**SUBJECT:** NuScale Power, LLC Response to NRC Request for Additional Information No. 9104 (eRAI No. 9104) on the NuScale Topical Report, "Evaluation Methodology for Stability Analysis of the NuScale Power Module," TR-0516-49417, Revision 0

NuScale Response to NRC Request for Additional Information eRAI No. 9104

**eRAI No.:** 9104

Figure 1 Percent relative thermal conductivity degradation per 10 MWD/kg burnup

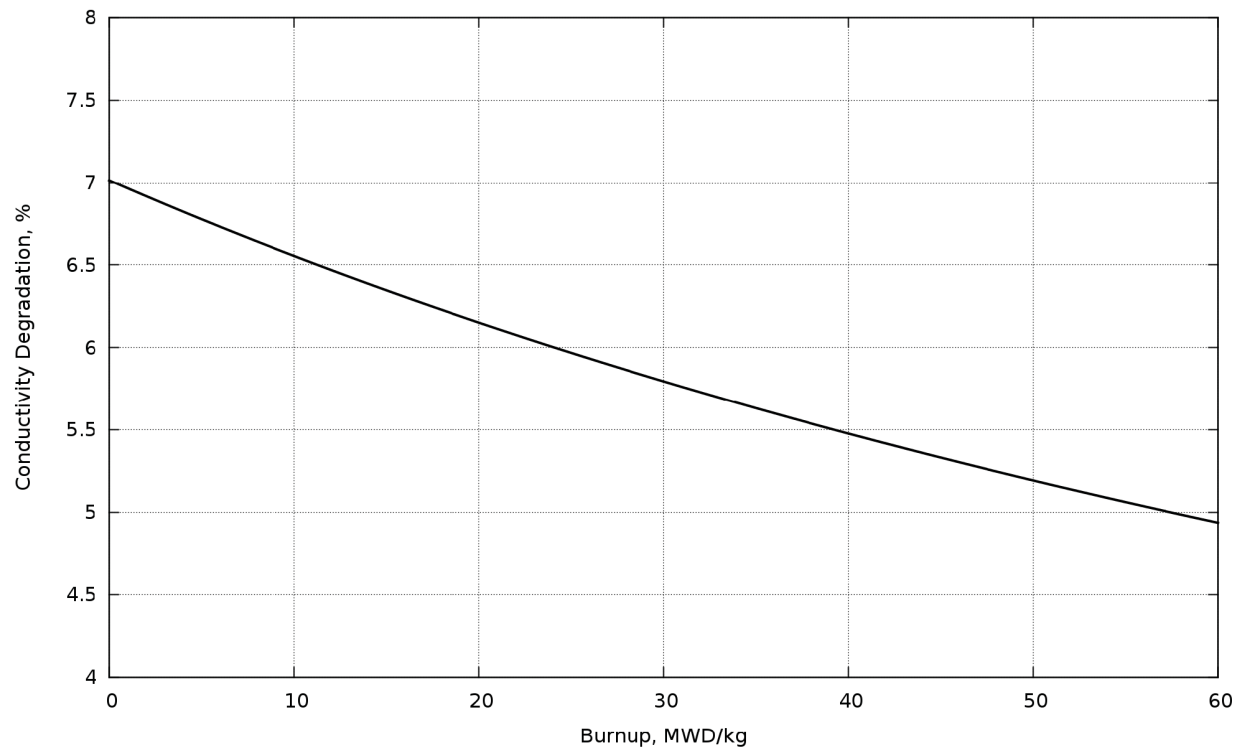
In section 5.6.4.4, "Pellet Centerline and Average Temperature," of the stability topical report, TR-0516-49417-P, describes the pellet conductivity dependence on burnup. However rationale for using the local exposure dependent fuel thermal conductivity model noted in this section (section 5.6.4.4) is requested below.

In order to make an affirmative finding NRC staff requests NuScale to provide justification of the exposure dependent fuel thermal conductivity model. It is acceptable to respond to this RAI by providing validation of the model against data.

Eqn. 5.108 for irradiated UO<sub>2</sub> thermal conductivity given in stability topical report TR-0516-49417-P is a simplification of Eqn. of 2.52 of FRAPCON-3.5 code report (Ref. 1). The same simple form of the thermal conductivity as function of temperature and burnup is used in Eqn. 3.3 of FRAPCON-3 report (Ref. 2) in Section 3.2 Experimental Evidence for Burnup Degradation.

In Section 3.2 of Ref. 2, experimental evidence of thermal conductivity degradation cited the Halden Ultra-High-Burnup Experiment. The experiments indicated degradation in uranium fuel thermal conductivity (averaged over the temperature range from ~750 to 1200K) of ~5 to 7%

relative per 10 GWd/MTU, for burnups up to 88 GWd/MTU. This magnitude of thermal conductivity degradation is in good agreement with the formula used in PIM as shown in Figure 1.

Figure 1 is a plot of the percent relative decrease of thermal conductivity per 10 MWD/kg burnup at a temperature of 900 K, versus burnup. The relative degradation is obtained directly from Eqn. 5.108 of the TR as:

Figure 1 shows the percent relative degradation in the correct experimental range of ~5 to 7%.
